Project No. 35077

Amendment No. 1

**ERCOT Standard Generation
Interconnection Agreement**

**FIRST AMENDMENT TO THE ERCOT STANDARD
GENERATION INTERCONNECTION AGREEMENT**

Exhibit "C2a"

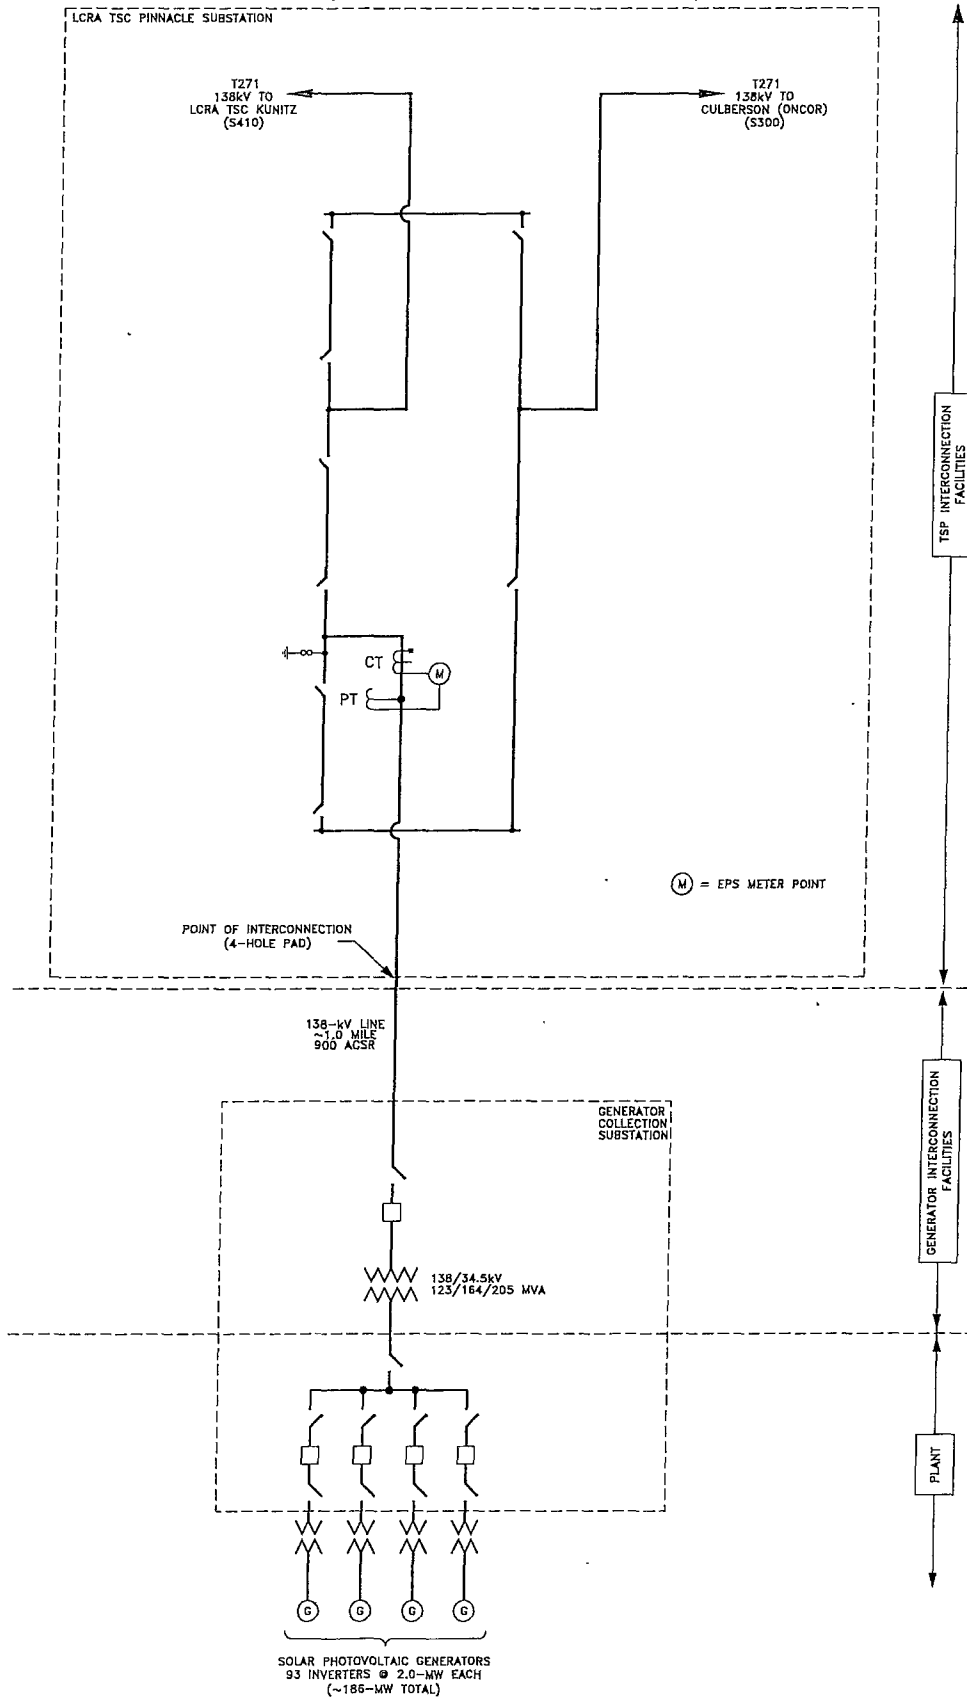
WHEREAS, Generator notified TSP of a change in the design of the Plant as originally contemplated in the Agreement.

1. Exhibits "B", "C", "C2", "C3" and "E" are deleted in their entirety and Exhibits "B", "C", "C3" and "E" attached to this First Amendment are hereby added to the Agreement in lieu thereof.
2. Exhibits "B", "C", "C2a", "C2b", "C3" and "E" attached to this First Amendment will become effective upon execution of this First Amendment by the Parties.
